IEEE802.1 Interim Geneva January 2018

Update of Figure 6-3 Time Synchronisation Deployment cases

8 January 2018

G.8271.1-Y.1366.1(17)_F7-1

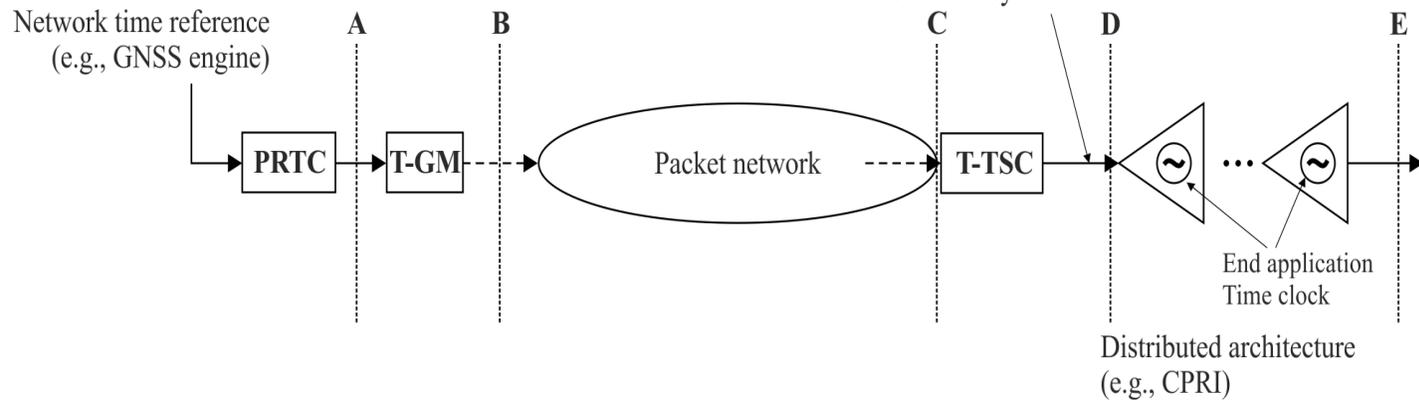
In deployment case 1, reference point D might not be accessible. The network limits at point D are for further study.

In deployment case 2, the network limits applicable at reference point D are the same as specified in clause 7.3 for deployment case 1, reference point C.

Generally, Point D should be defined inside End Applications in Deployment case 1.

Figure 6-3—ITU-T G.8271.1 deployment cases in the scope of this standard

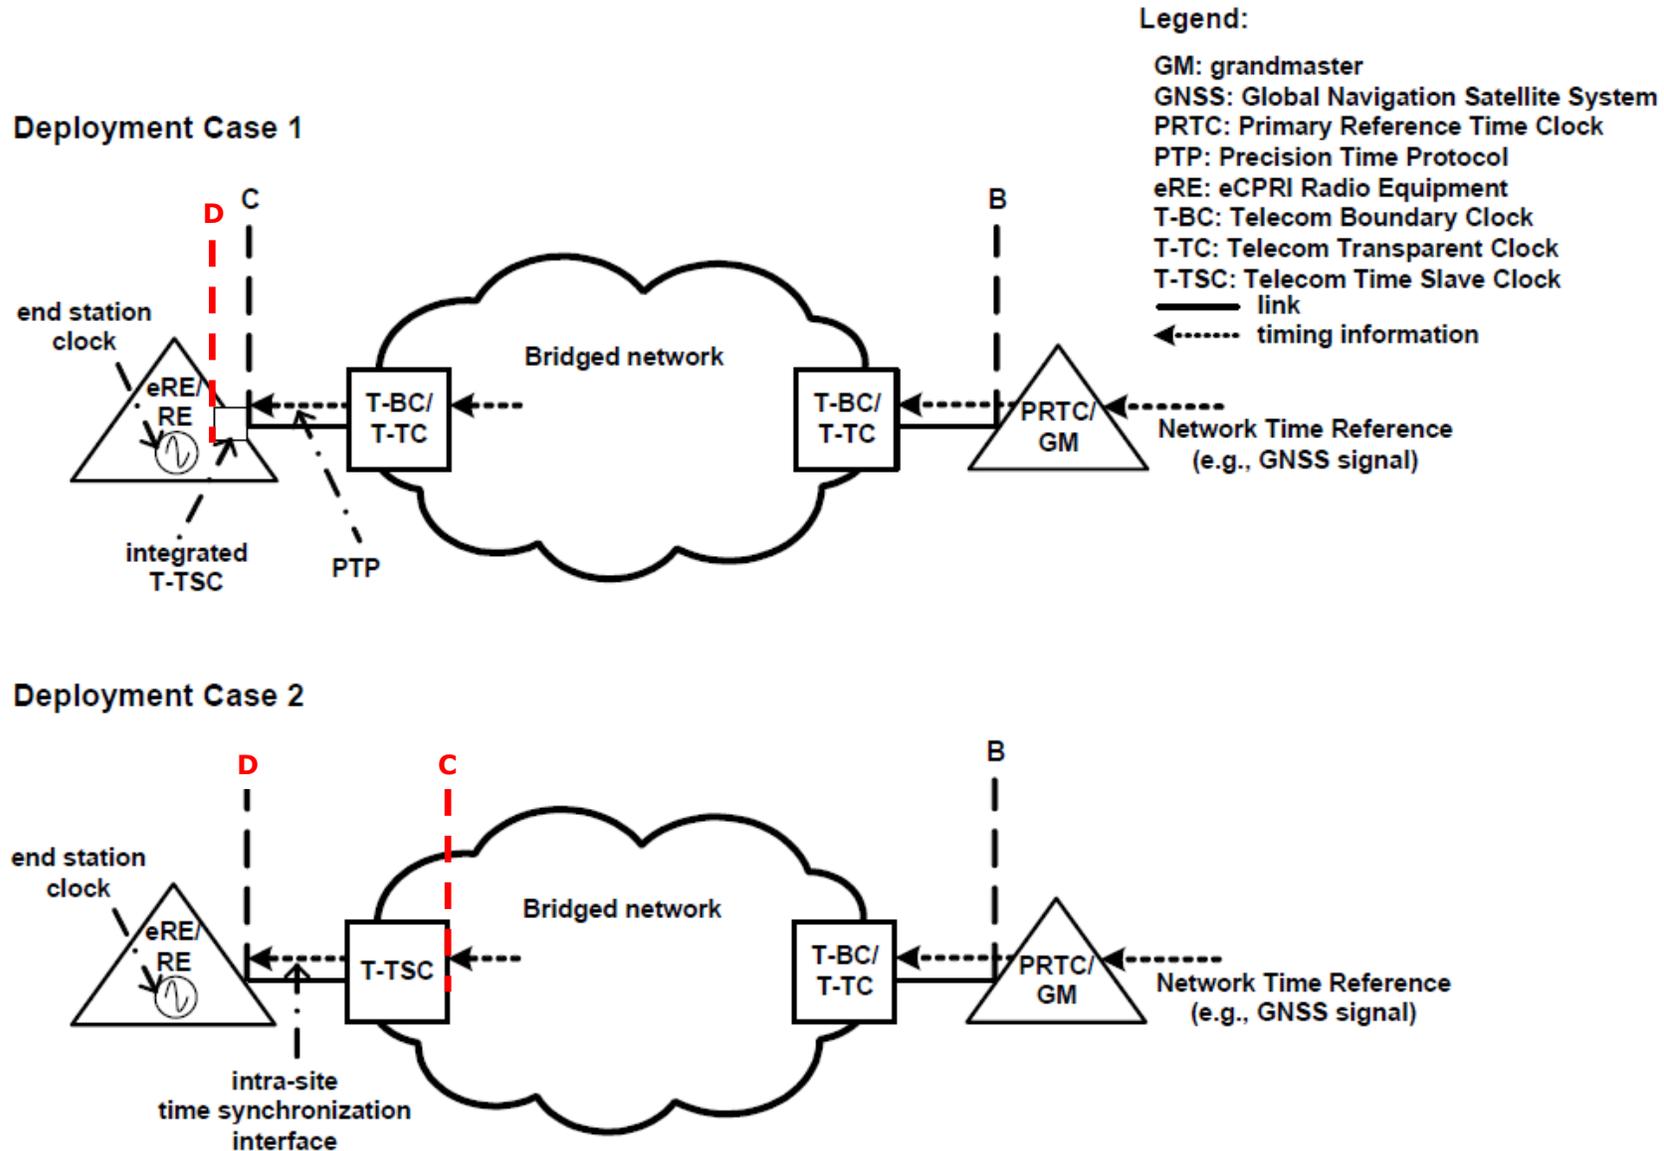
Suggested remedy and update to Figure 6-3 in P802.1CM/D1.2

- Figure 6-3 in P802.1CM/D1.2 should be updated according to the latest ITU-T G.8271.1(10/17) Sec7.4.
- It is proposed to update figure 6-3 as shown in the next slide in red by adding Reference Point "D" inside eRE on Deployment Case 1, and to move and add Reference Point " C " and " D "on Deployment Case 2 (also shown in red).
